ESHID-603647

Subject: Response to Administratively Incomplete Determination Part A and General Part B of the Resource Conservation and Recovery Act (RCRA) Permit Renewal Application Los Alamos National Laboratory EPA ID#NM0890010515, HWB-LANL-20-001

**Response to Administratively Incomplete
Determination Part A and General Part B of the
RCRA Permit Renewal Application Los Alamos
National Laboratory EPA ID#NM0890010515,
HWB-LANL-20-001**

Plate 1.

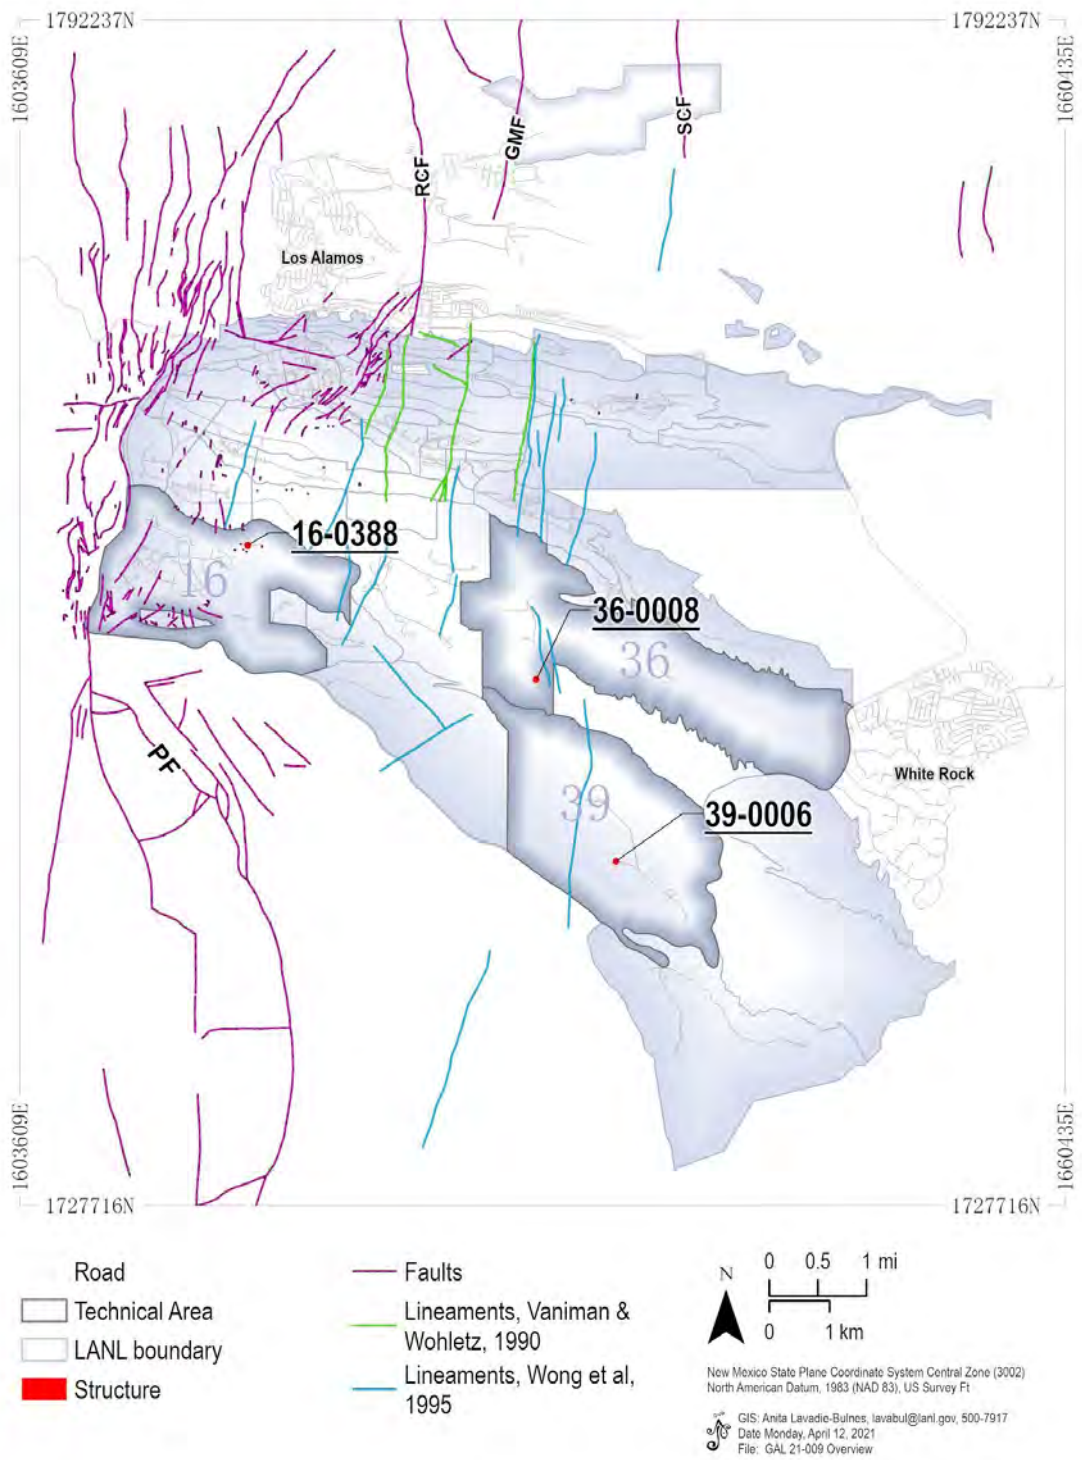
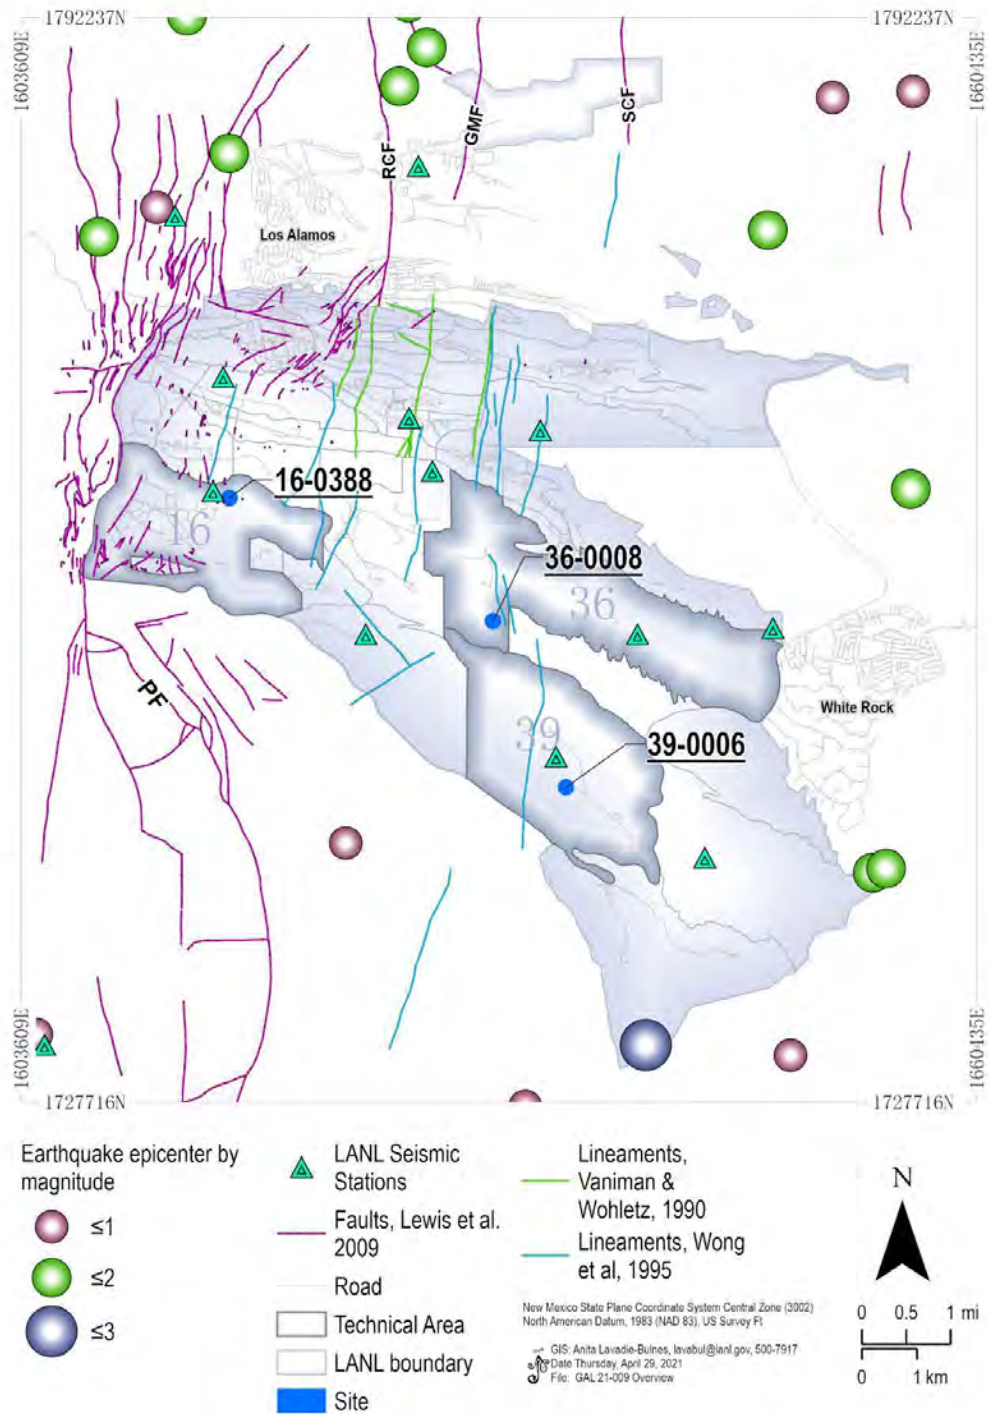
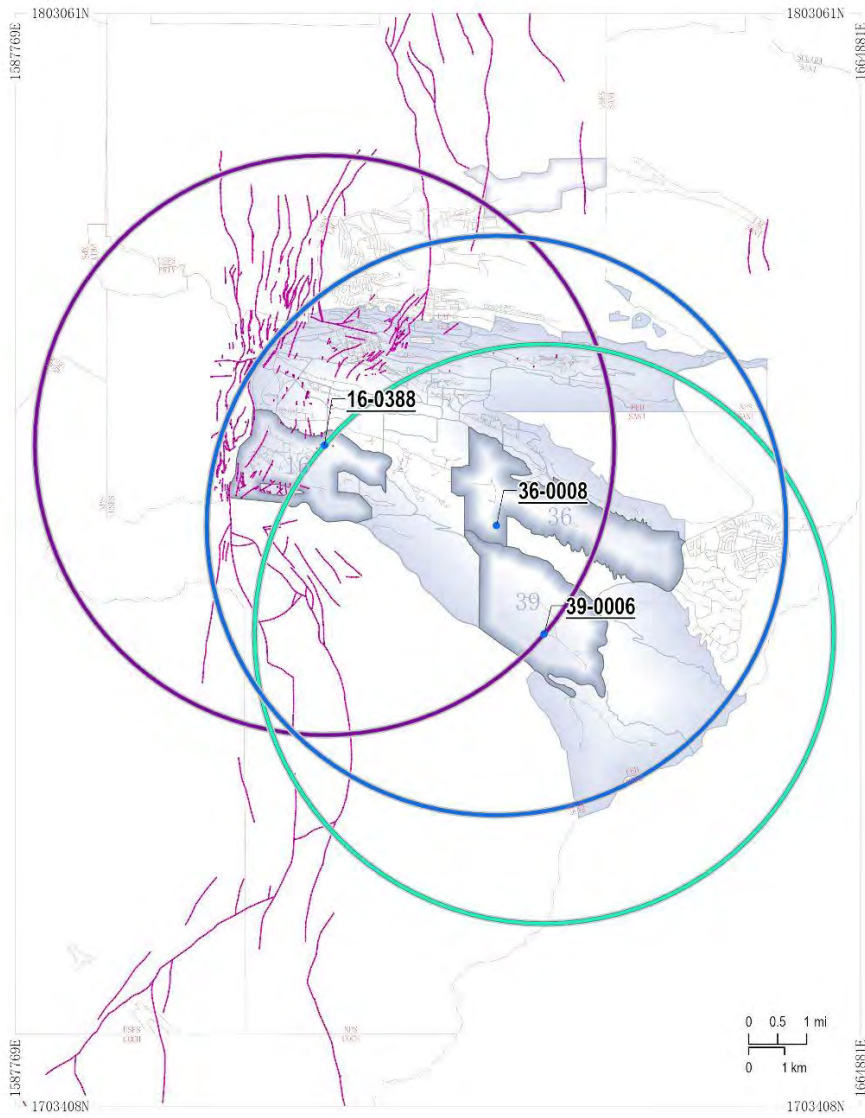
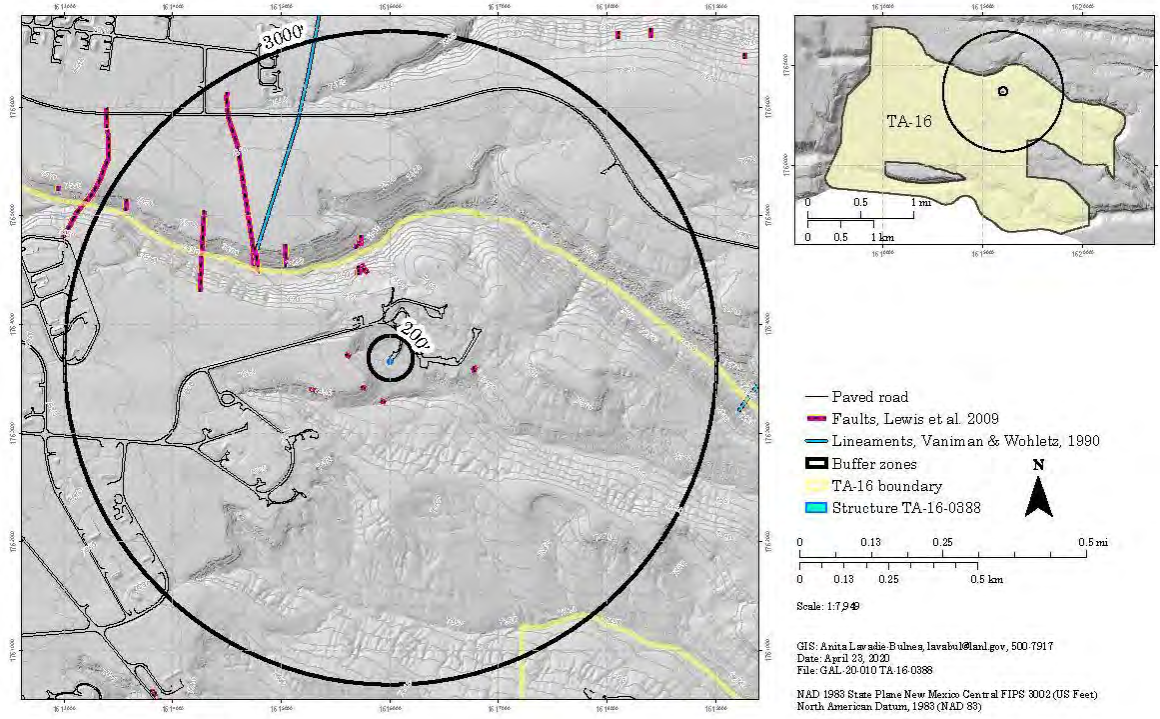
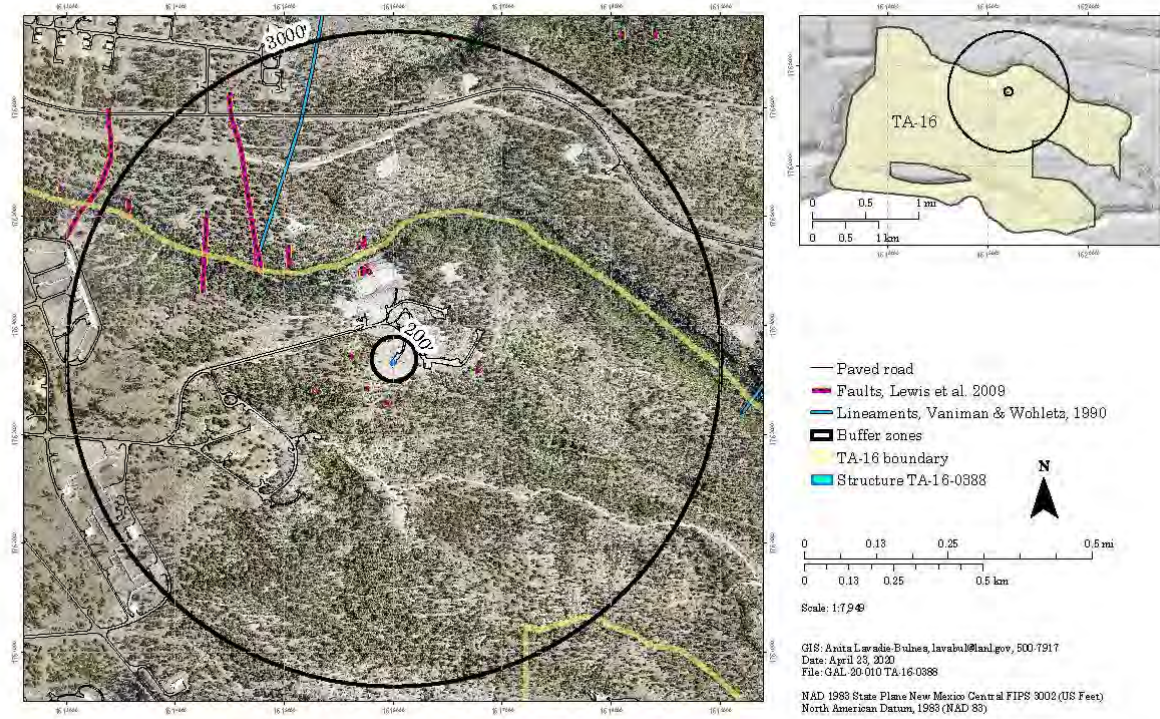
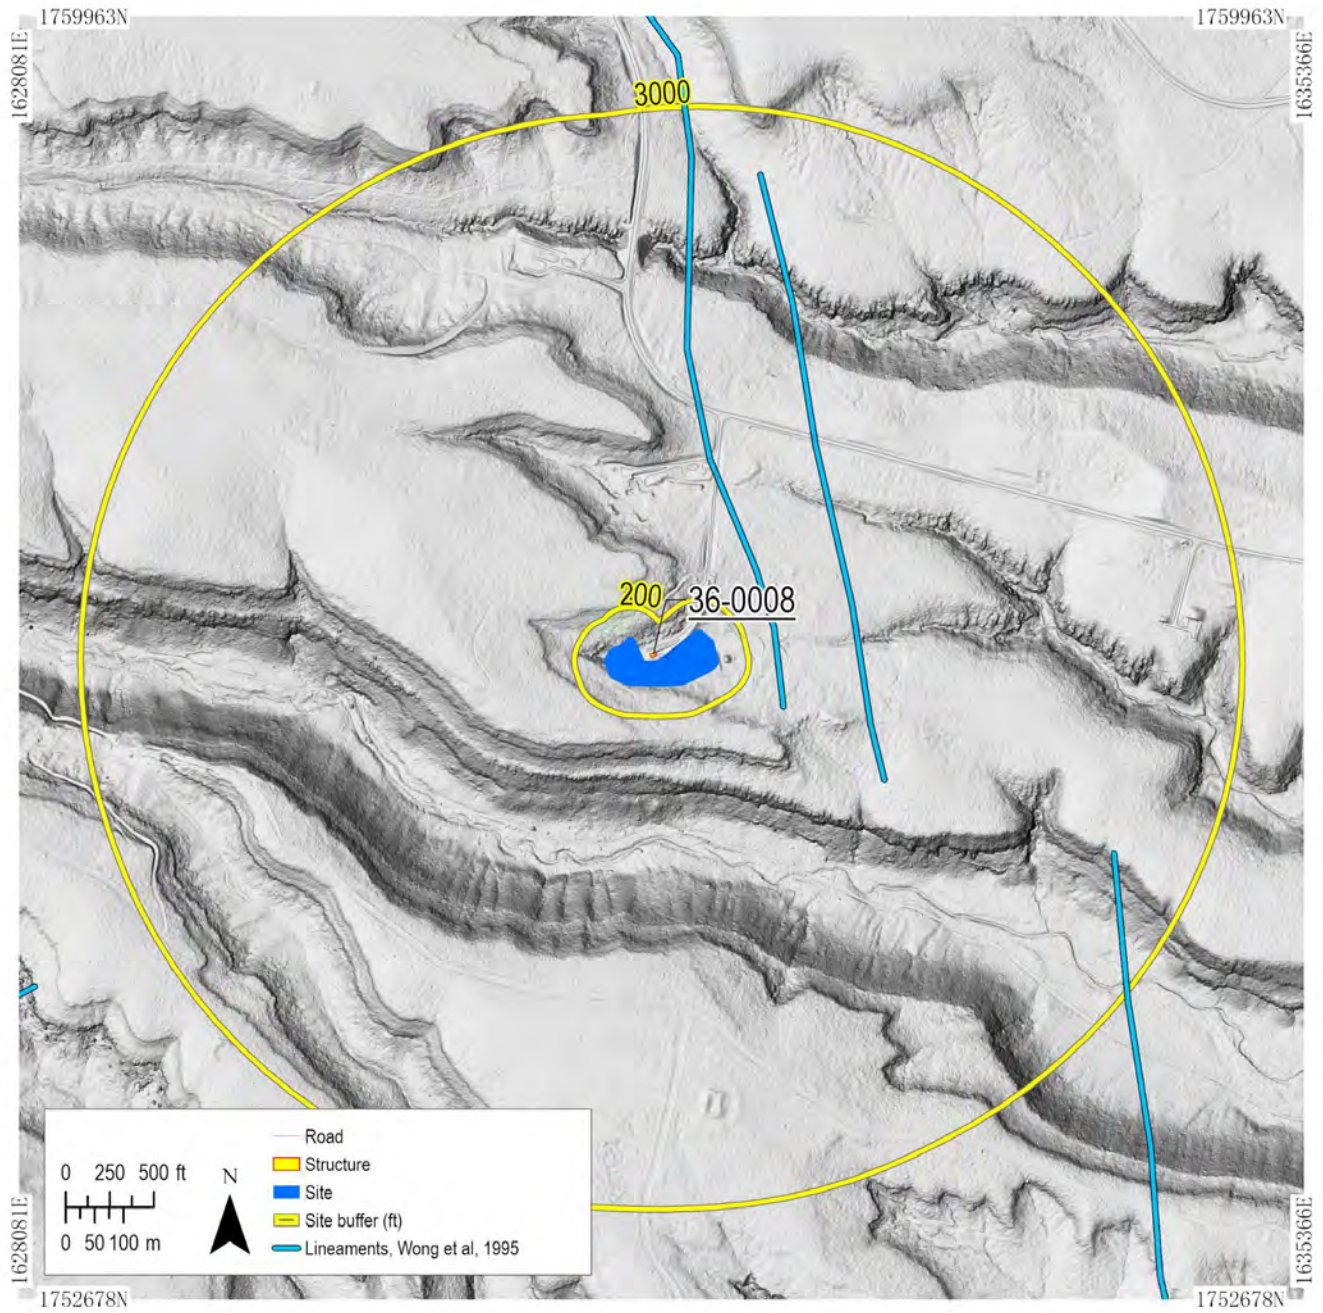
Appendix VI of 40 CFR 264, therefore, the Permittees must provide geologic data which demonstrates compliance with the seismic standard (see 40 CFR 270.14 (b)(11) for more information). The Permittees must provide seismic information for the three (3) waste treatment units proposed to be included in the permit (i.e., Technical Area (TA) 16-388, 36-8, and 39-6).

Attachment 3 includes maps and seismic location information for the proposed open burning and open detonation units at TA-16-388, TA-36-8, and TA-39-6. Text reflecting the addition of the seismic location information is added to the Permit Renewal Application Section 2.10.1, *Seismic Standard* in Attachment 4 of this response. Although the seismic investigation included in Attachment 3 demonstrates that there has been no direct evidence observed for Holocene faulting within the required radius of the facility, it is noted within the seismic report that field reconnaissance may be required to confirm the determination, as field activities are delayed due to COVID 19 safety restrictions.

Figure 2-3. Wind Roses (day and night **averaged for the 365 days of 2018**)

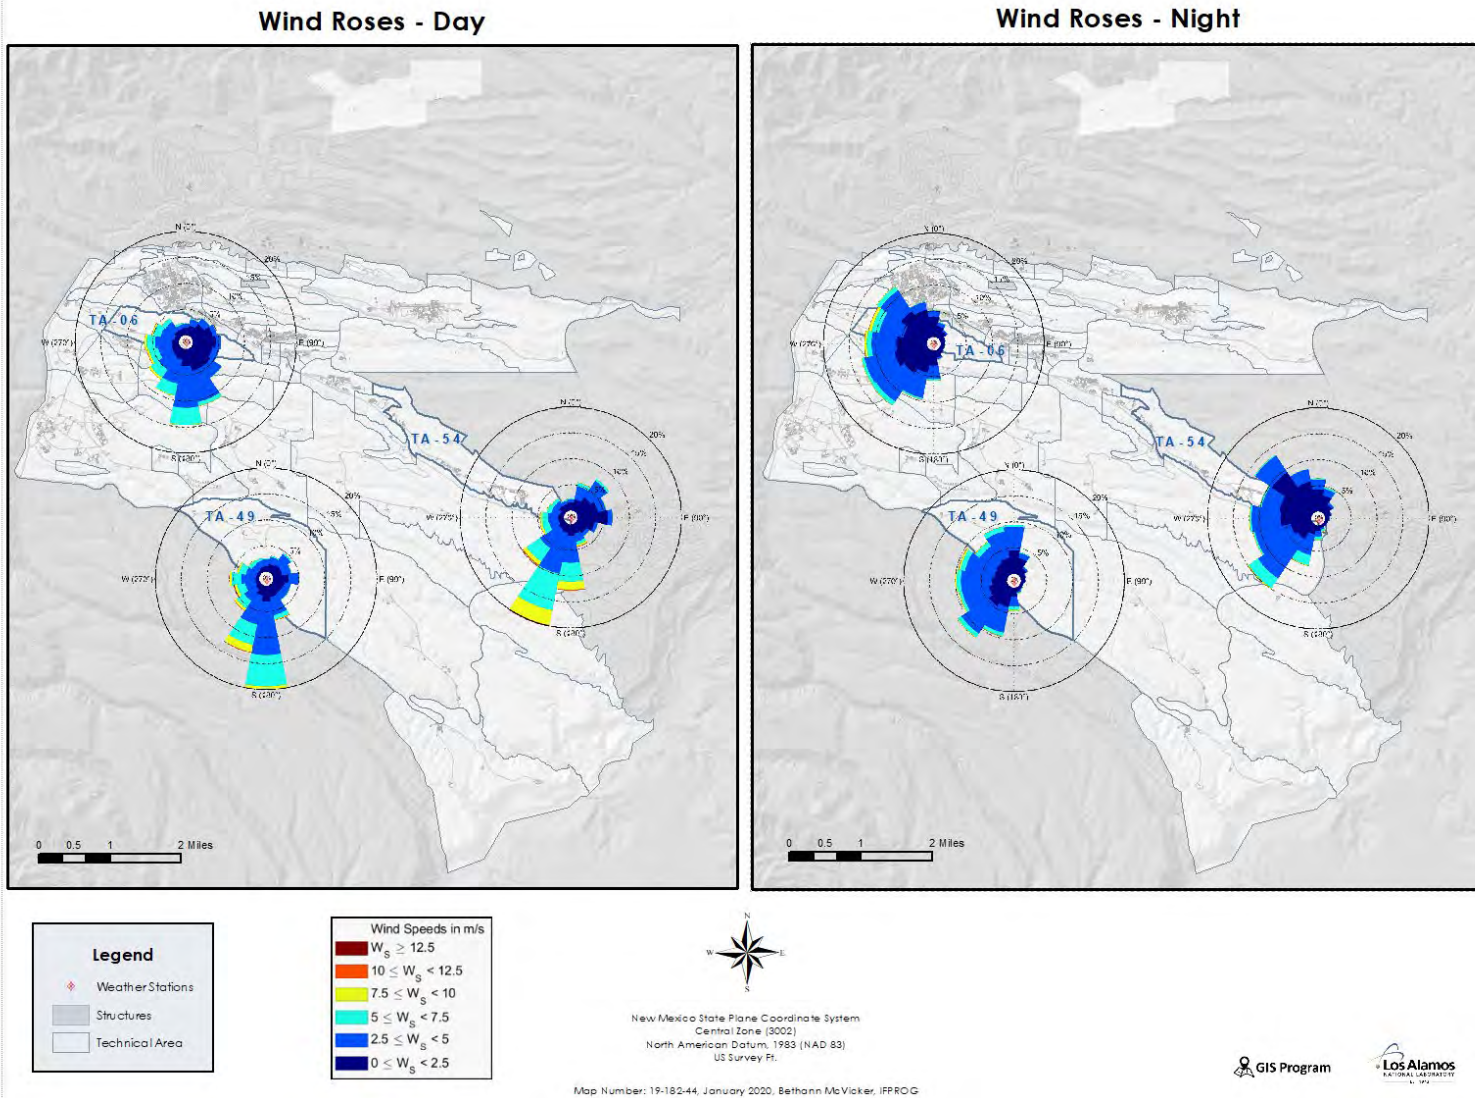
7. Section 2, Figure 2-3 Wind Roses (Day and Night), page 2-24:

Permit Renewal Application Figure 2-3 is revised (in Attachment 4) to include the year and total days that the wind roses were based upon. These wind roses were drafted based on winds from all 365 days of 2018. In general, wind roses from different years are almost identical in terms of the distribution of wind directions, indicating that wind patterns are constant when averaged over a year. As detailed in the Los Alamos Climatology 2016 Update (<http://permalink.lanl.gov/object/tr?what=info:lanl-repo/epr/ESHID-602502>), there are four meteorology towers on the mesa tops at LANL at TA-6, TA-49, TA-53, and TA-54. The TA-53 location was not included in the Permit Renewal Application figures because it was deemed to be too far from any of the hazardous waste management units within the Permit or units in interim status. The other three meteorology towers are included in the Permit Renewal Application because they are the closest towers to the permitted and interim status hazardous waste management units. The distance for the TA-6 tower to the interim status units is: TA-36-8, ~4.26 miles; TA-39-6, ~5.5 miles; and TA-16-388, ~1.4 miles. The distance from the TA-49 tower to the interim status units is: TA-36-8, ~1.13 miles; TA-39-6, ~2 miles; and TA-16-388, ~3 miles. For completeness and comparison, the day and night 5-year averaged wind roses for 2016 through 2020 are included as Attachment 5 of this response. The 5-year wind rose data further illustrate that the wind rose information for each of the towers demonstrate very little difference with the exception of the 2018 wind roses that show slightly more intense winds over the single year average compared to the 5-year average.
